# Access Compliance Report

## Public Rights-of-Way

### (Curb Ramps)

Intersection ID: 10028291	Main Street: HENRY_DAVID_CT	Cross Street: N/A	Location: E
ADA ID: E4434F673BA9	Ramp Type: Perp	Initial Pass/Fail: Fail	Overall Compliance: No
Severity Score: 10			
Codes/Mitigation Info/Possible Solution		Field Measurements/Component Compliance

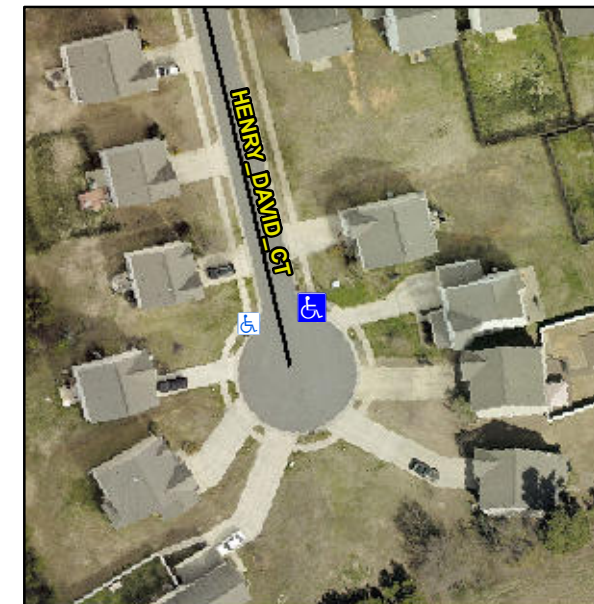
**Not Found, R304.5.1, R304.5.3**

Compliance	Description	Data	Compliance	Description	Data
N/A	Ramp Length (in)	49.0	Yes	Ramp Slope (%)	7.1
No	Ramp Width (in)	47.5	No	Ramp XSlope (%)	2.9
N/A	Flare Type LT	N/A	N/A	Flare Type RT	N/A
N/A	Flare Slope LT (%)	N/A	N/A	Flare Slope RT (%)	N/A
N/A	Flare Traversable LT?	N/A	N/A	Flare Traversable RT?	N/A
N/A	Landing Length (in)	N/A	N/A	DWS Provided?	N/A
N/A	Landing Width (in)	N/A	N/A	DWS Contrast?	N/A
N/A	Landing Slope (%)	N/A	N/A	DWS Length (in)	N/A
N/A	Landing X Slope (%)	N/A	N/A	DWS Full Width?	N/A
N/A	Landing Curb? (Y/N)	N/A	N/A	DWS Offset (in)	N/A
N/A	Shared Landing?	N/A			
N/A	Gutter Ponding?	N/A	N/A	Gutter Slope (%)	N/A
N/A	Gutter Lip Ht (in)	N/A	N/A	Gutter X Slope (%)	N/A
N/A	Painted X Walk1?	No	N/A	Painted X Walk2?	N/A
	X Walk 1 Direction	To W		X Walk 2 Direction	N/A
N/A	X Walk 1 Width (in)	N/A	N/A	X Walk 2 Width (in)	N/A
	X Walk 1 Slope (%)	1.7		X Walk 2 Slope (%)	N/A
	X Walk 1 X Slope (%)	0.6		X Walk 2 X Slope (%)	N/A

**Remove & Replace Entire Ramp.**
